# Adams School Redevelopment

## **Addendum No. 2** to Contract Documents

March 23, 2012

**S1.1**

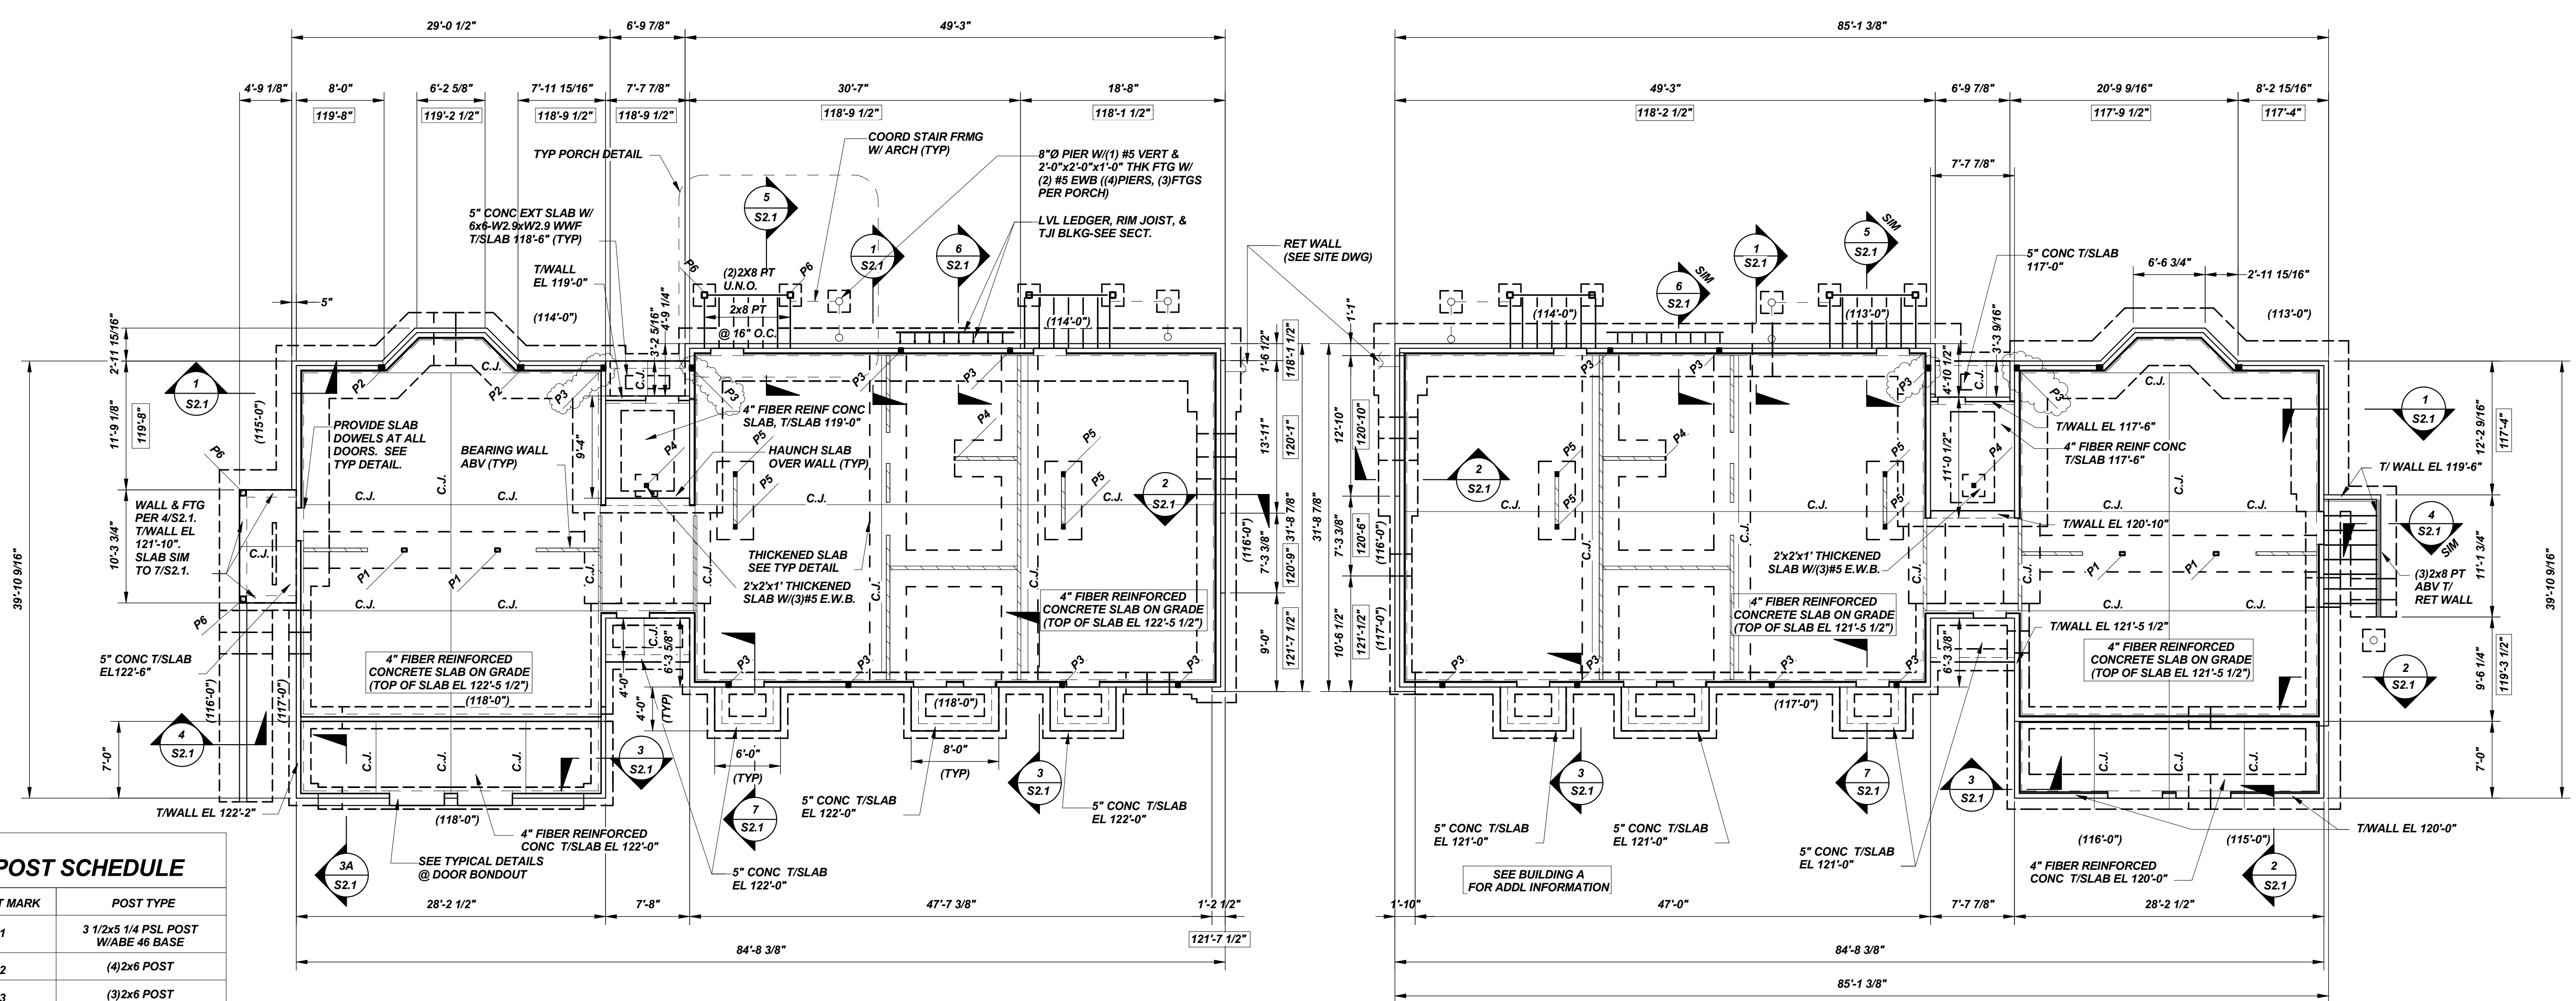
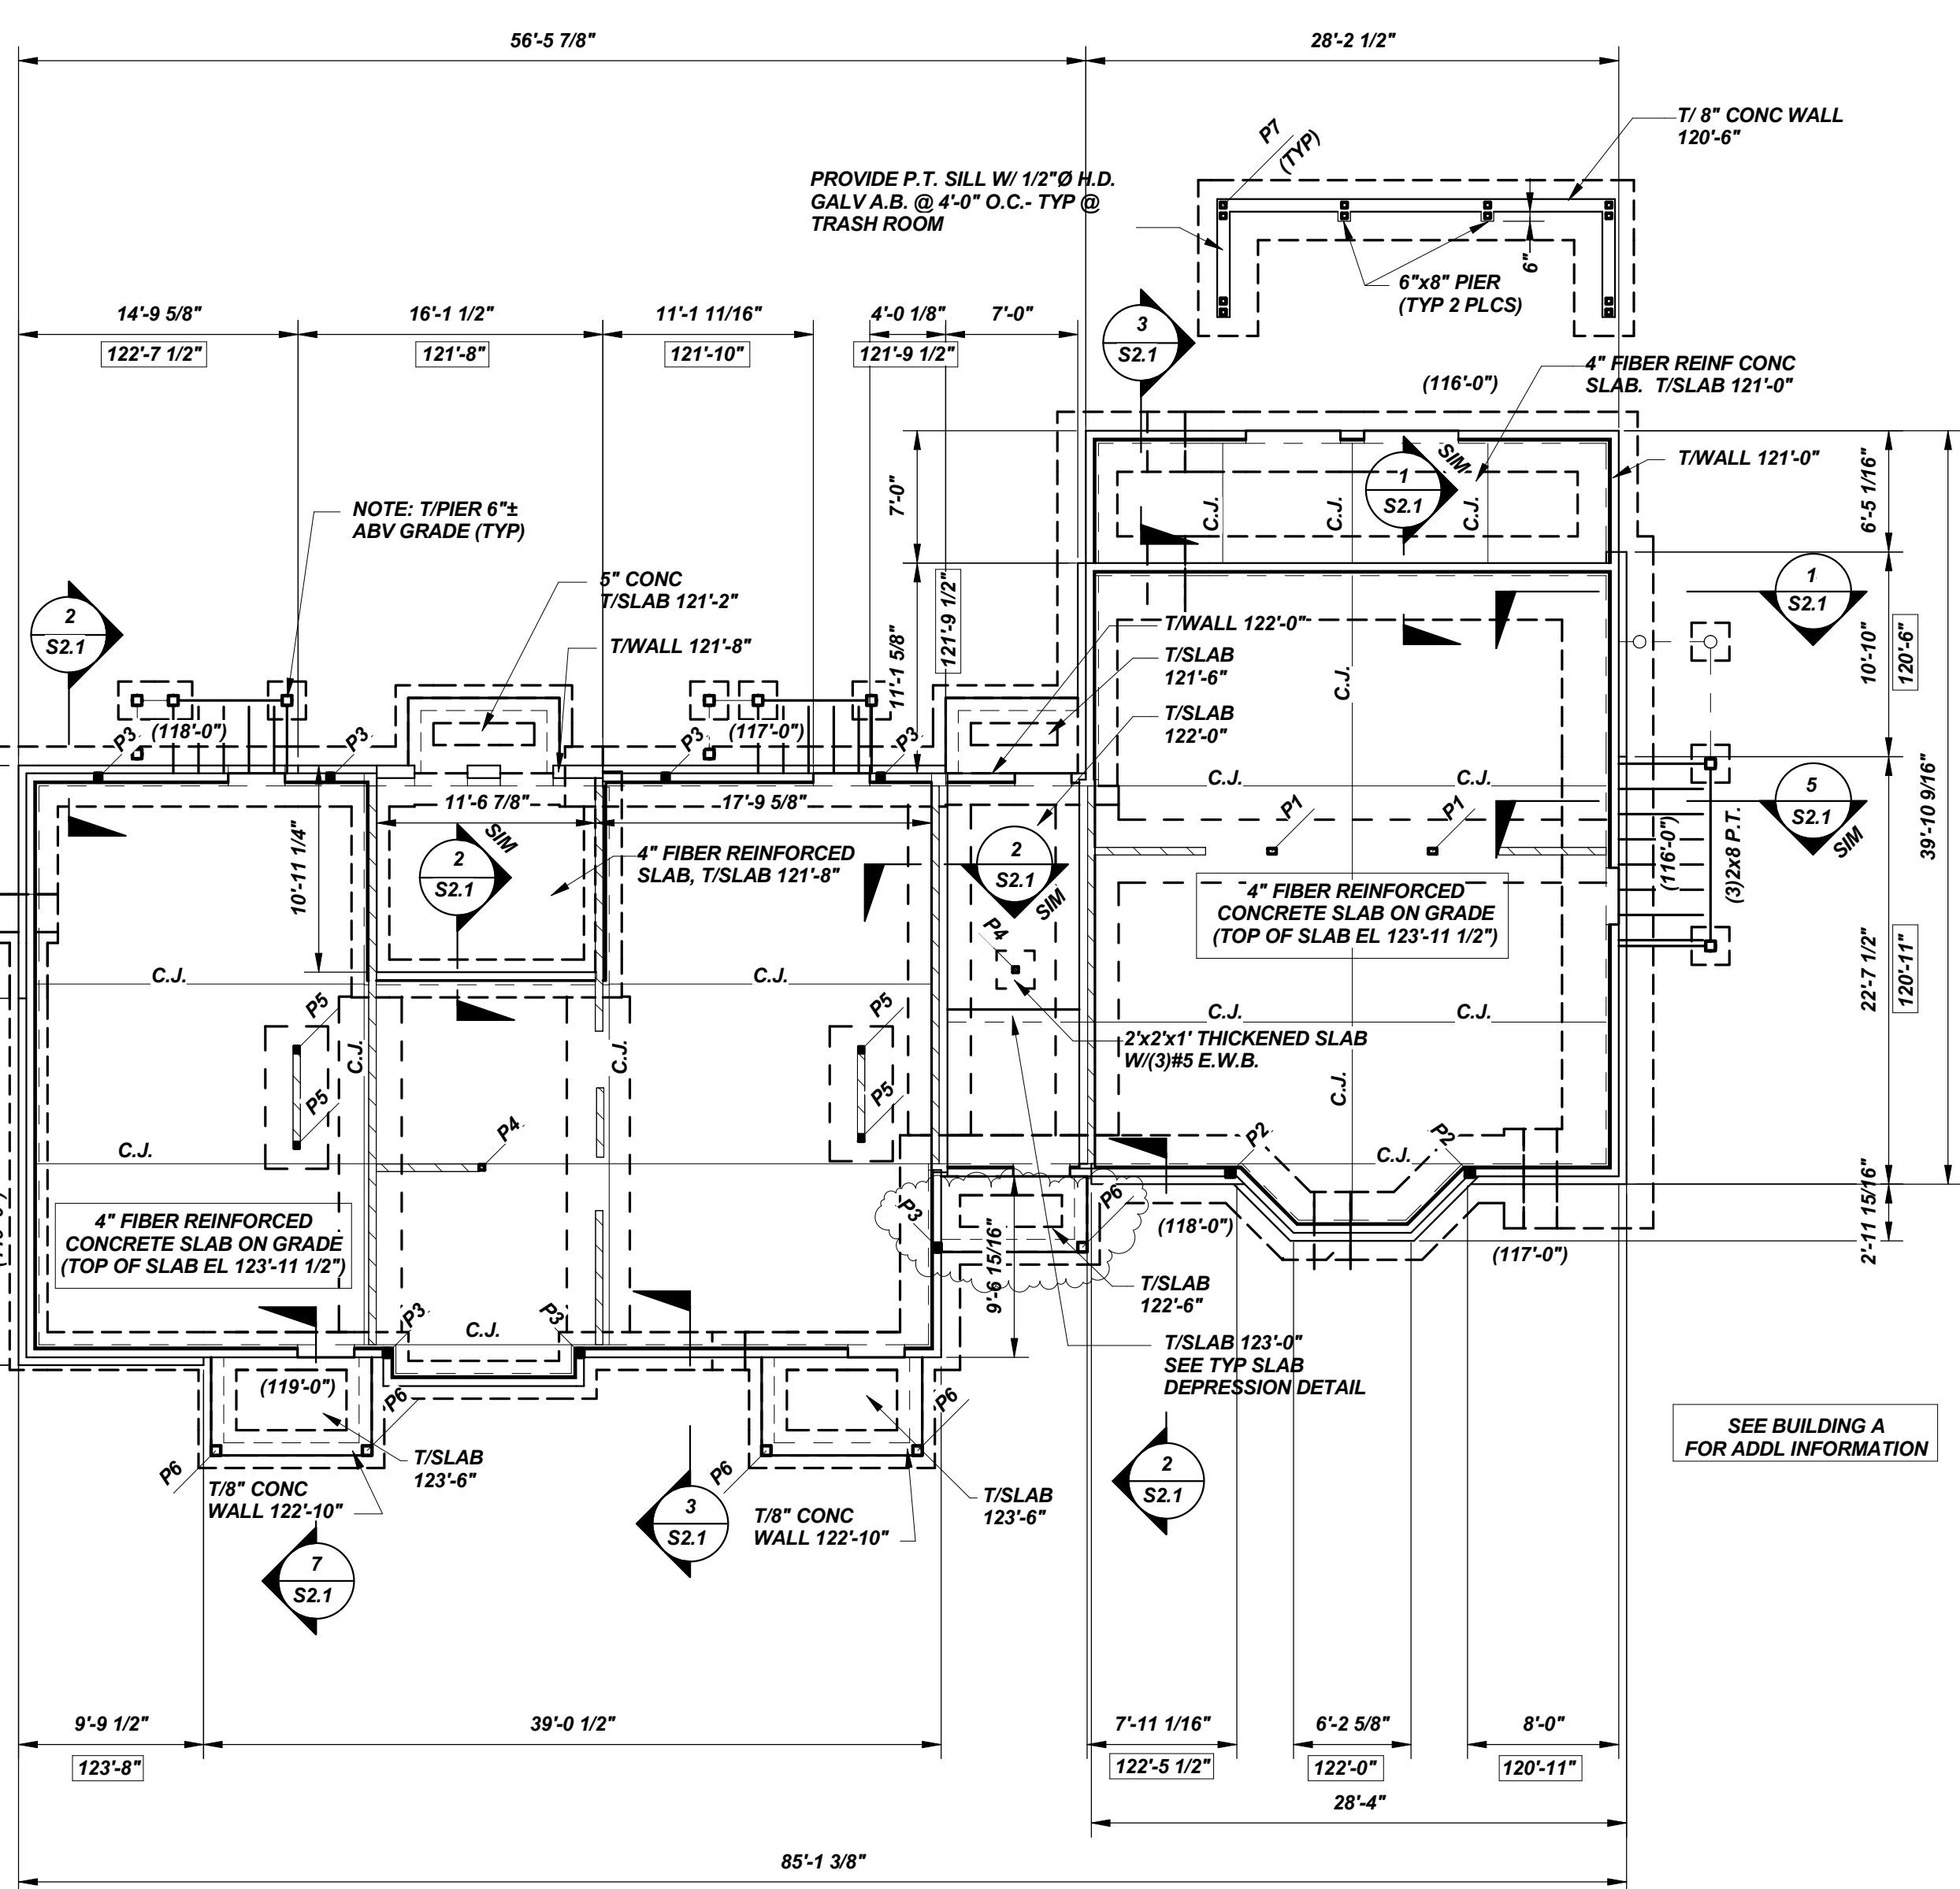
- Sheet S1.1: MODIFY as shown on attached S1.1/Addendum 2.  
Sheet S1.2: MODIFY as shown on attached S1.2/Addendum 2.  
Sheet S1.3: MODIFY as shown on attached S1.3/Addendum 2.

**SKS-1**  
INDICATED REVISIONS-PAGE 1 OF 3
